DeKalb County Department of Planning & Sustainability

STAFF ANALYSIS

Case No.:	Z-19-1243163	Agenda #: N. 6	
Location/Address:	3398 Briarcliff Road	Commission District: 2 Super District: 6	
Parcel ID(s):	18-195-09-002		
Request:	To rezone property from R-100 (Residential-Medium Lot-100) to RSM (Small Lot Residential Mix) to develop 21 urban single-family detached dwelling units.		
Property Owner(s):	Walter, Jeff, and David Pendergr	ast	
Applicant/Agent:	Greg Ramsey		
Acreage:	8.7 acres		
Existing Land Use:	A single-family residence.		
Surrounding Properties:	Single-Family Residential		
Adjacent Zoning:	North: R-100 South: R-100 Eas Northwest: R-100 Southeast: R	t: R-100 West: R-100 Northeast: R-100 R-100 Southwest: R-100	
Comprehensive Plan:	Suburban	X Consistent Inconsistent	
Proposed Density: 2.4 units/acre		Existing Density: .11 units/acre	
Proposed Units: 21 Existing Units: One		Existing Units: One	
Proposed Lot Coverage: 30% Existing Lot Coverage: (Estimated) less than			_

Site Plan

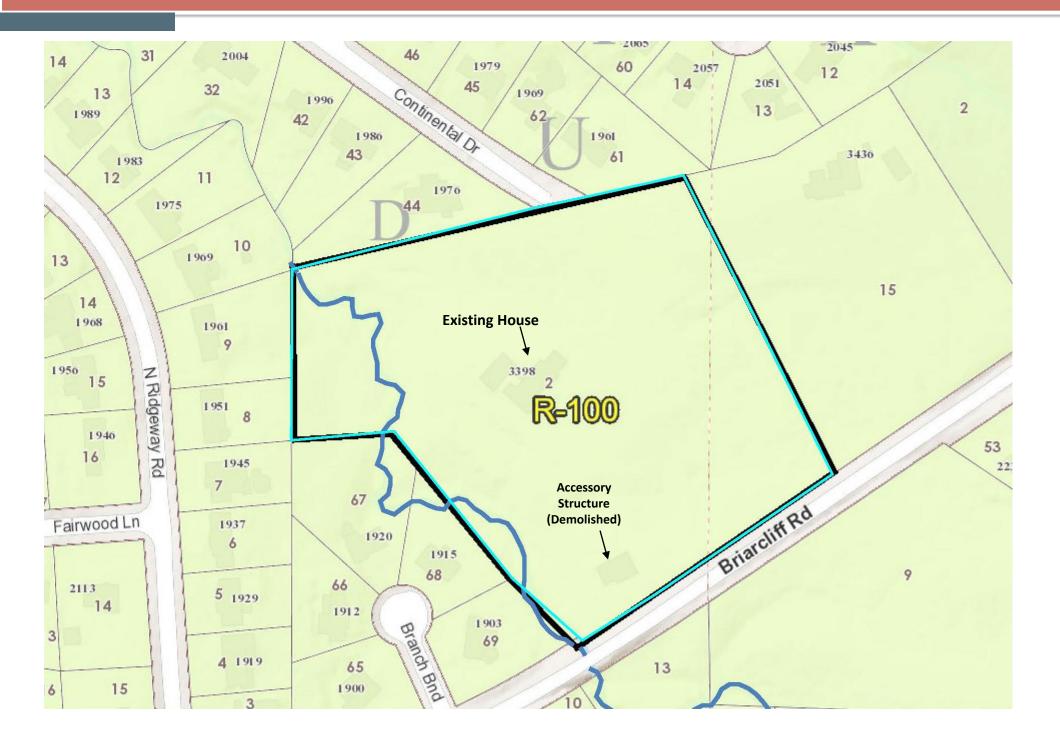
- 1. The subject property shall be developed in substantial conformity with the lot layout, allocation and distribution of open space, and location of amenities shown on the site plan titled, "Zoning Plan for the Pendergrast Historic Farm", prepared by JVG Civil Engineering, dated 9/12/17, revised 2/27/19 and 3/7/19, and stamped as received by the Department of Planning and Sustainability on March 7, 2019.

The property owners neighboring the proposed Pendergrast Farm development would like to convey that, as a whole, they support the conservation aspirations in the proposed Rezoning Application. However, they do not support the proposal in its current form and have several concerns related to ingress/egress, emergency response time, and parking.

First, the proposed rezoning may not provide adequate access for emergency vehicles via the Continental Drive ingress/egress. The Applicant has indicated that the proposed units are being marketed to aging residents as an option for downsizing their current housing needs. The drive time from Briarcliff Road to the proposed ingress/egress, through the convoluted streets, is considerably longer.

Second, the proposed ingress/egress will most certainly create additional traffic via Fischer Trail and Chrysler Drive that would produce unsafe road conditions for pedestrians in the immediate area, including walkers, babies in strollers, and joggers.

Third, the proposed ingress/egress could lead to overflow vehicle parking along Continental Drive. The number of parking spaces proposed for the 1600 to 3000 square foot units may be insufficient. Overflow parking will certainly cause further congestion and impede emergency service access.

We believe that alternative plans could be developed with an entry from Briarcliff Road, that enables the developer to maintain the desired conservation characteristics, including me preservation of pervious surfaces. In conclusion, the undersigned neighboring property owners believe the safest and best access to the proposed development would be an ingress and egress via Briarcliff Road. We respectfully ask you to consider these issues in your deliberations.
